1977 Corvette: Service Bulletin: Anti-Theft Alarm Switch - Protective Grease

Bulletin No: 77-T-57

Date: Oct., 1977

FIGURE #1 - DOOR LOCK/ANTI-THEFT SWITCH INSTALLATION

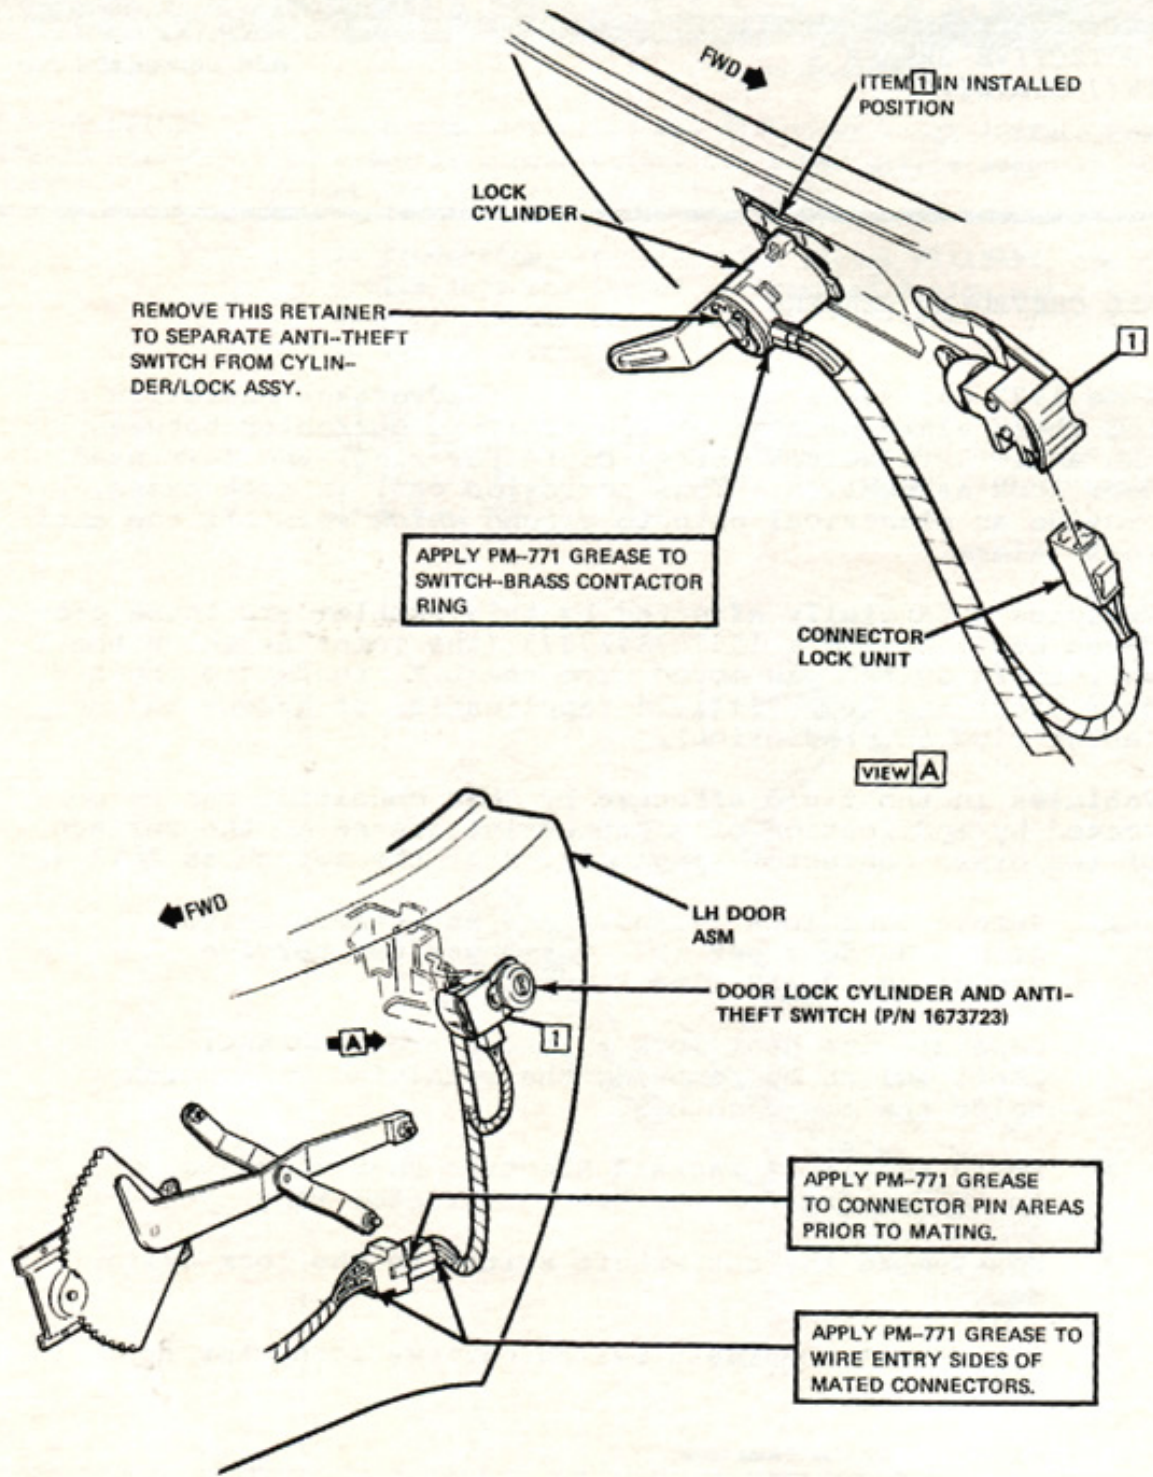
Some 1977 Corvettes may experience inadvertent operation of the theft alarm because of electrolytic corrosion between the anti-theft switch (brass contactor ring) and left hand door lock assemblies. This corrosion can, in some cases, provide an electrical path to ground which sets off the anti-theft alarm.

1. Remove door lock cylinder and anti-theft switch from L.H. door per 1977 Passenger Car Service Manual pg. 2D-19 (See Figure 1).
2. Separate the door lock cylinder from the anti-theft switch by removing the retaining ring which holds the two together.
3. Apply a film of Packard Electric PM-771 grease to the surface of the

brass contactor ring.

4. Reassemble the anti-theft switch to the lock cylinder.
5. Disconnect the theft switch harness connector from the door wiring harness connector and apply the same grease to connector pin areas. Reassemble connectors and apply this grease to the wire entry sides of the mated connectors.
6. Reassemble the door lock cylinder and anti-theft switch to the L.H. door per Service Manual instructions.

A satisfactory substitute for Packard Electric PM-771 grease is GM P/N 1050109 or 1050110.
